**Economic and Social Council**Distr.: General
10 February 2021

Economic Commission for Europe**Inland Transport Committee****World Forum for Harmonization of Vehicle Regulations****Working Party on Lighting and Light-Signalling****Eighty-third session**

UN Regulations Nos. 37 (Filament lamps), 99 (Gas discharge light sources), 128 (Light emitting diodes light sources) and the Consolidated Resolution on the common specification of light source categories**Proposal for amendment to the Consolidated Resolution on the common specification of light source categories (R.E.5)****Submitted by the Task Force on Substitutes and Retrofits***

The text reproduced below was prepared by the Task Force on Substitutes and Retrofits (TF SR), with the aim to introduce a new light emitting diode replacement light source (LEDr) category C5W. It takes into account the proposal in ECE/TRANS/WP.29/GRE/2020/16/Rev.1 for the introduction of the LEDr H11 category. The technical provisions are based on the equivalence criteria (informal document GRE-83-15). The modifications to the existing text of the Resolution are marked in bold for new or strikethrough for deleted characters.

Figure 1

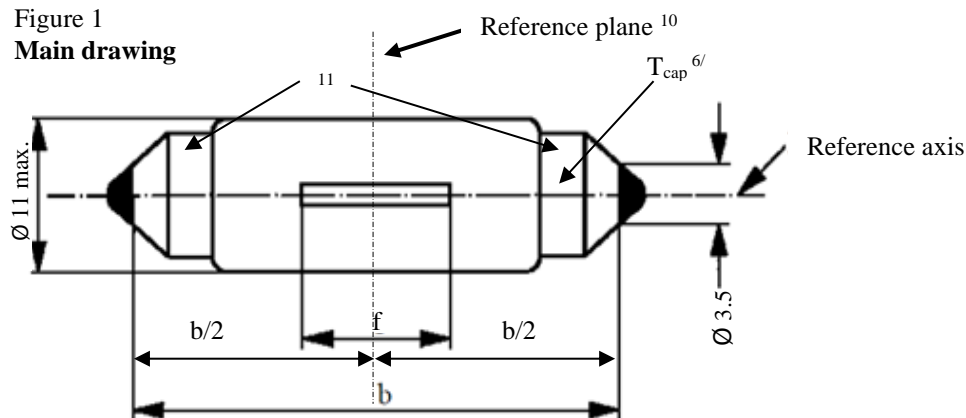
After sheet C5W1/LED/4, insert new sheets C5W_LED_r/1 to 4, to read:

<i>LED light sources of normal production</i>	
<i>Dimensions in mm</i>			
b ^{1/}		35.0 ± 1.0	
f ^{2/}		9.0 nom.	
Elevated ambient air temperature ^{4/}		50°C	
Cap SV8.5 in accordance with IEC Publication 60061 (sheet 7004-81-4)			
<i>Electrical and photometric characteristics</i> ^{5/}			
Rated values		Volts	12
		Watts	3 ^{9/}
Test voltage (DC)		Volts	13.5
Objective values	Power ^{7/}	Watts	2.5 min. ^{8/} 5.5 max. ^{9/}
	Electrical current ^{7/} at 12-14 V DC	mA	150 min. ^{8/}
	Luminous flux ^{3/}	lm	$45 \pm 20 \%$
	Luminous flux ^{3/} at 9V DC	lm	9 min.
	Cap temperature T_{cap}	°C	75 max. ^{8/}

- ¹ This dimension corresponds to a distance between two apertures of 3.5 mm diameter each bearing against one of the caps.
- ² To be checked by a “box system”, see Figure 2.

Figure 2

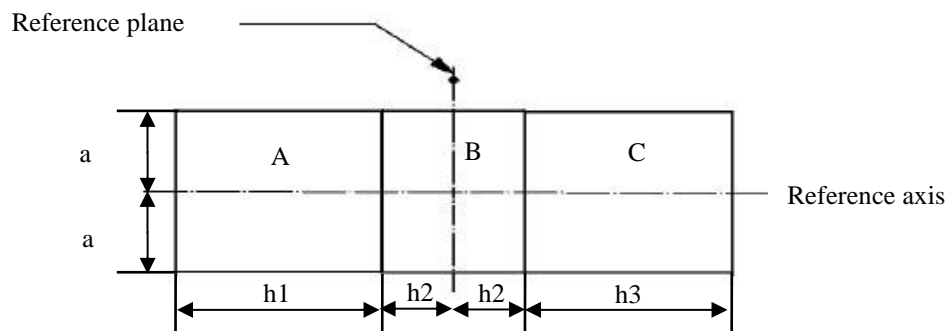
The position of the light emitting area is checked by means of a box system defined by the projections when viewing along the direction $\gamma = 0^\circ$ (top view), $\gamma = 90^\circ$ (front view), $\gamma = 180^\circ$ (bottom view), $\gamma = 270^\circ$ (rear view) in the plane C_0 (C, γ as defined in Figure 3).

The proportion of the total luminous flux emitted into these viewing directions from the area(s) as defined in figure 2:

- A, B and C together shall be 70 per cent or more;
- B shall be 20 per cent or more;
- A and C shall each be 15 per cent or more.

These values shall be calculated as percentage of the total luminous flux emitted into the viewing direction from the maximum light source outline, i.e. a rectangle of length $b = 36.0$ mm and a height of 11 mm, aligned symmetrically to the reference axis and reference plane (see Figure 1).

Figure 3

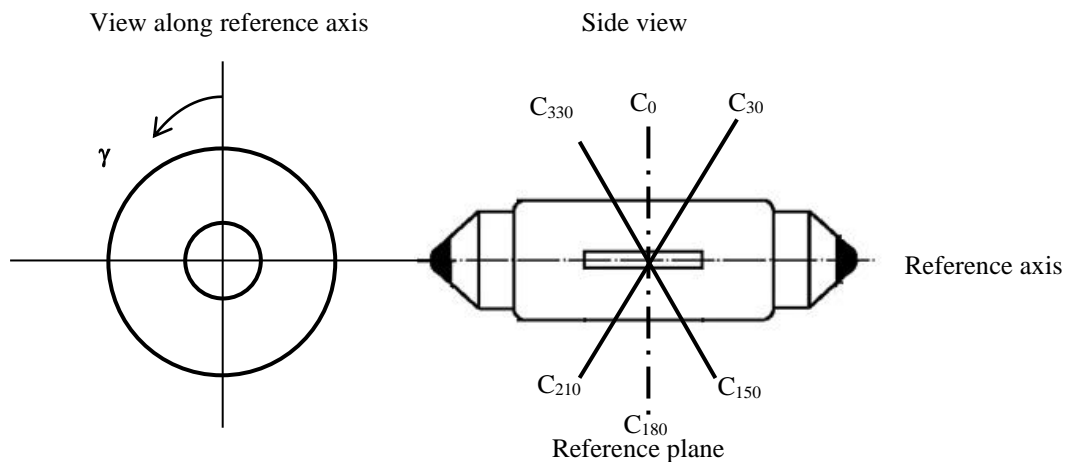
The following test is intended to determine the normalized luminous intensity distribution of the light source in the C-planes as described in figure 3. The intersection of the reference axis and the reference plane is used as the coordinate system origin.

The light source is mounted on a flat plate with the corresponding holder features. The plate is fixed to the goniometer table by a bracket, so that the reference axis of the light source lines up with one of the rotating axis of the goniometer. The corresponding measurement set-up is described in figure 3.

The measurements shall be performed in C-planes, where C_0 (C_{180}) shall be the reference plane of the light source. The C-planes to be measured shall be those specified in Table 3. The test points for each plane and multiple polar angles γ are specified in Table 3.

The measured luminous intensity values, normalised to the measured luminous flux of the individual light source under test, shall be converted to normalised luminous intensity values of a 1000 lm light source. These data shall comply with the tolerance band as defined in Table 3.
